QUALITY ASSURANCE -- NON-CONFORMANCE REPORT

Report No: NCR-000748

NCR #: ZPMC-0711

Reference Description: Improper welding process was utilized in repair of Bike path assembly BK004A-004

Component: Bike path assembly BK004A-004

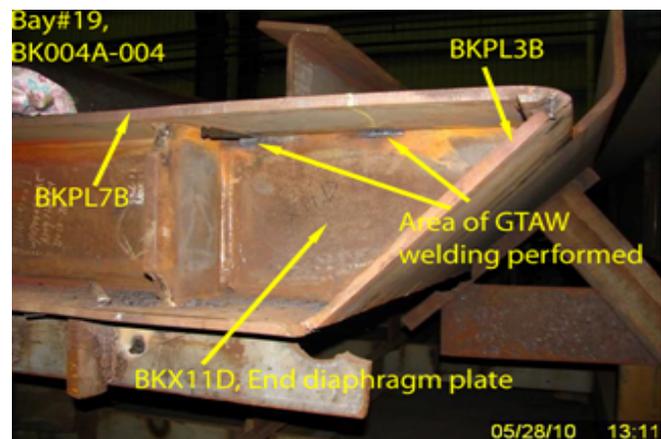
During random in-process visual inspection of bike path assembly BK004A-004, this Quality Assurance (QA) Inspector discovered the following issue:

- Weld buttering being performed at the leading edge of an intended tight fit joint, between the end diaphragm plate (BKX11D) and the bearing plate (BKPL7B) with an unapproved welding process.
- The welding process being utilized during the repair was Gas Tungsten Arc Welding (GTAW).
- The welder is identified as ZP09-1381.
- The ZPMC QC Mr. Zhou Cheng was unable to identify the consumables used at the time of welding.
- Bike Path: BK004A-004 is located in Bay 19.

Remove said welds and replace utilizing an approved welding process.

Welds were removed within the workshift and have since been replaced with the appropriate welding process.
